FORM APPROVED  
OMB NO. 1004-0135  
Expires: July 31, 2010**SUNDRY NOTICES AND REPORTS ON WELLS**  
*Do not use this form for proposals to drill or to re-enter an abandoned well. Use form 3160-3 (APD) for such proposals.*5. Lease Serial No.  
NMNM82896

8. Well Name and No.  
NIMITZ 12 FEDERAL 5H9. API Well No.  
30-015-41657-00-X110. Field and Pool, or Exploratory  
POKER LAKE11. County or Parish, and State  
EDDY COUNTY, NM**SUBMIT IN TRIPLICATE - Other instructions on reverse side.**

OXY USA Inc. respectfully requests a variance to the approved APD for the following changes and additions to the drilling plan:

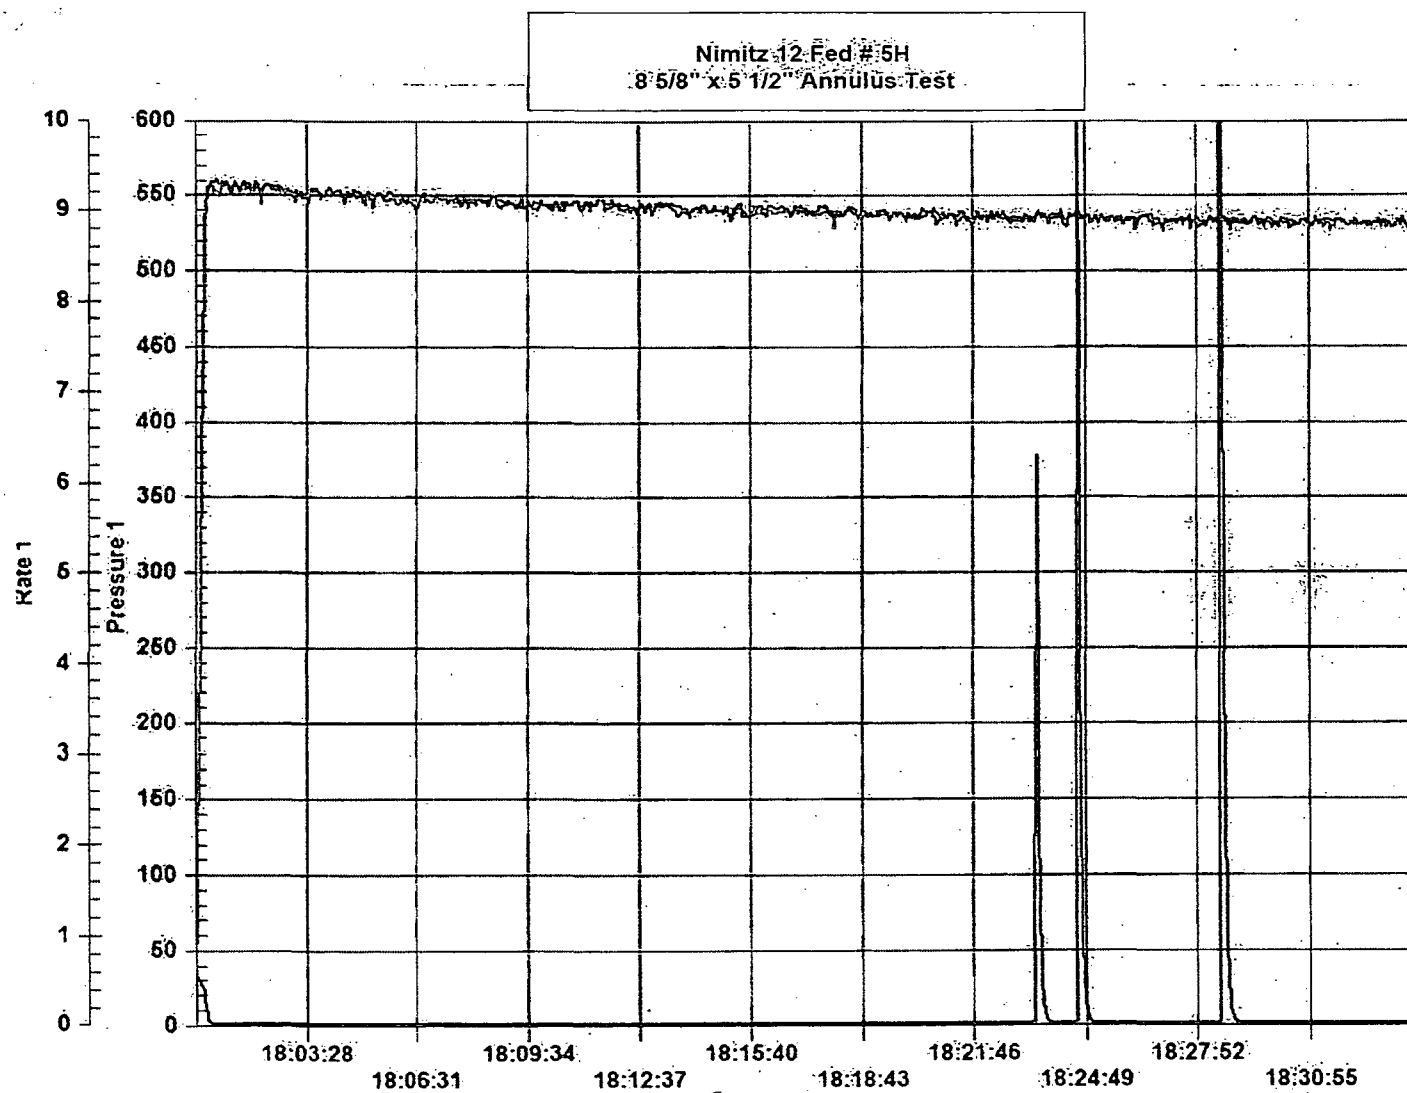
1. Production cement program adjustment to include actual TOC at ~1800' based on CBL. New excess volumes were calculated based off new TOC and actual volume pumped.
2. The 8-5/8" x 5-1/2" annulus was tested to 550psi for 30 minutes, testing chart attached.

The rate spikes are not real....its noise in the data.
